TEXAS NATURAL RESOURCE CONSERVATION COMMISSION

Re: EDWARDS AQUIFER, Comal County
PROJECT: Oakwood Estates, Project number 1298.00, Located approximately south of SH 337, and north and east of Elmwood Drive, New Braunfels, Texas
TYPE: Request for Approval of Water Pollution Abatement Plan (WPAP); 30 Texas Administrative Code (TAC) §213.5(b); Edwards Aquifer Protection Program

Re: EDWARDS AQUIFER, Comal County
PROJECT: Oakwood Estates, Unit 14, Project number: 1285.01
TYPE: Solution Feature/Sensitive Feature; 30 Texas Administrative Code (TAC)
§213.5(f)(2); Edwards Aquifer Protection Program

Re: EDWARDS AQUIFER, Comal County
PROJECT: Oakwood Estates, Unit 14, Project number: 1285.02
TYPE: Solution Feature/Sensitive Feature; 30 Texas Administrative Code (TAC) §213.5(f)(2); Edwards Aquifer Protection Program

ATTACHMENT 3

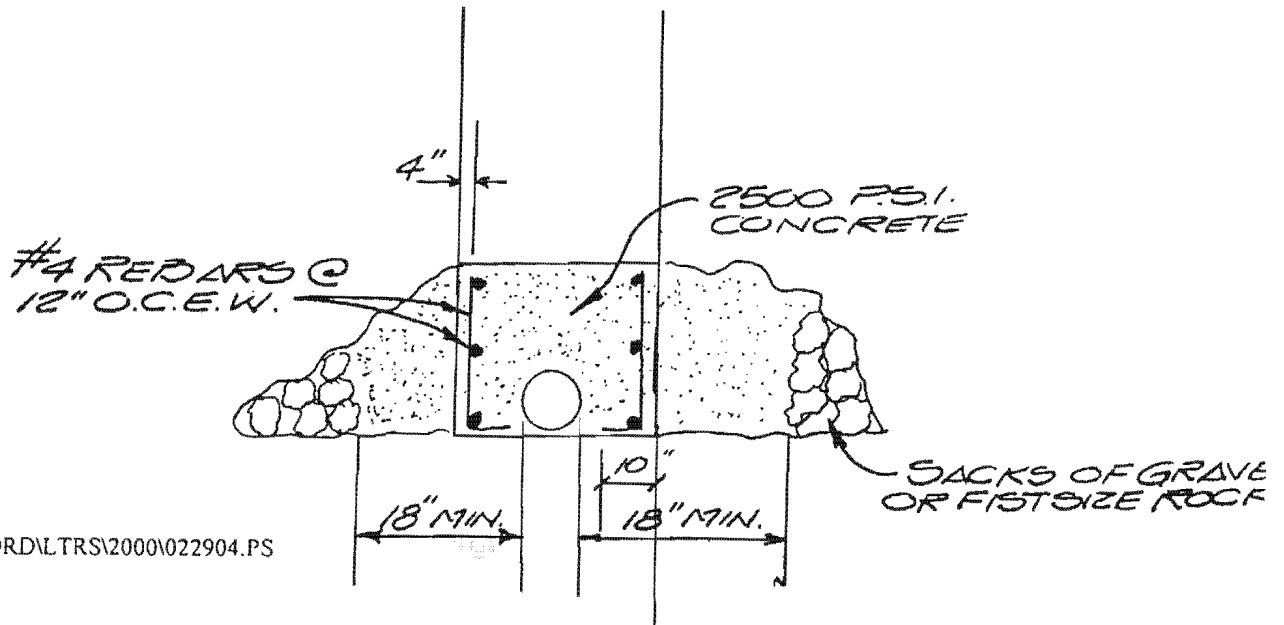
Feature A1-5 located at 0+50 on line "A" shall be filled with flowable fill concrete.

Feature A2-3 will require concrete encasement as shown below for a distance of five (5') feet either side of the feature.

ATTACHMENT 3

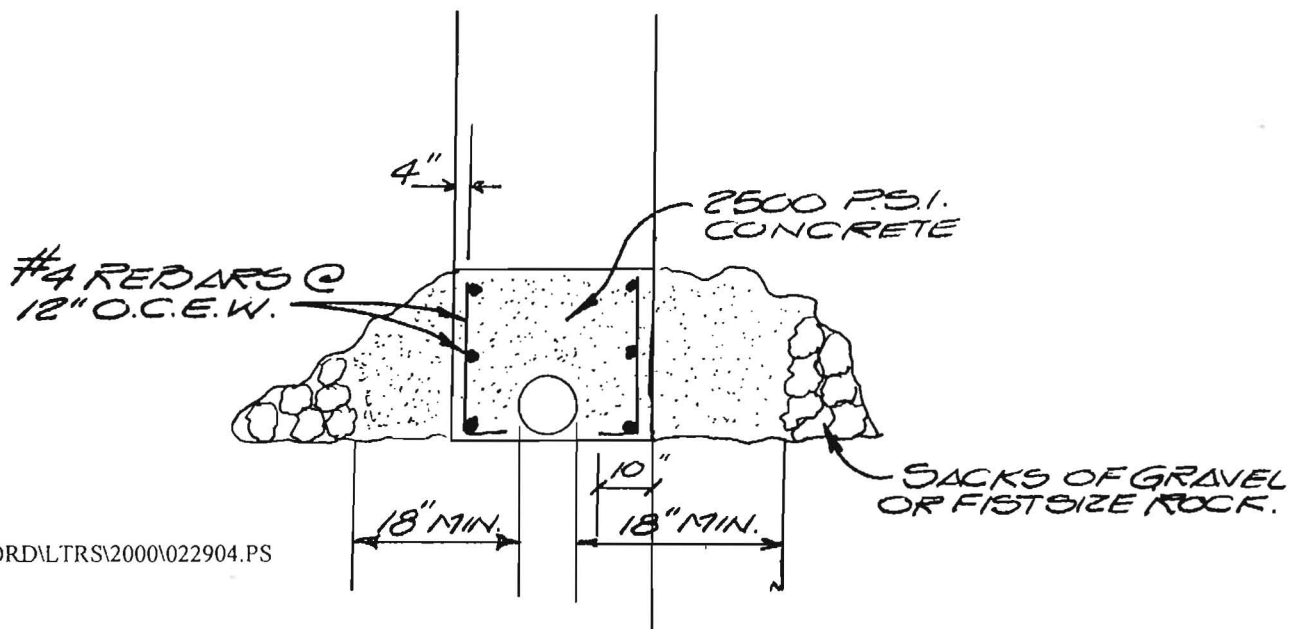
Feature A1-5 located at 0+50 on line "A" shall be filled with flowable fill concrete.

Feature A2-3 will require concrete encasement as shown below for a distance of five (5') feet either side of the feature.

1. The location of the solution feature shall be shown on the "as-built" plans.
2. Any concrete or concrete encasement shall meet or exceed New Braunfels Utilities (NBU) specifications for minimum thickness and compression strength.
3. Any steel reinforced concrete shall be with #4 Rebar, placed as shown on your plan.
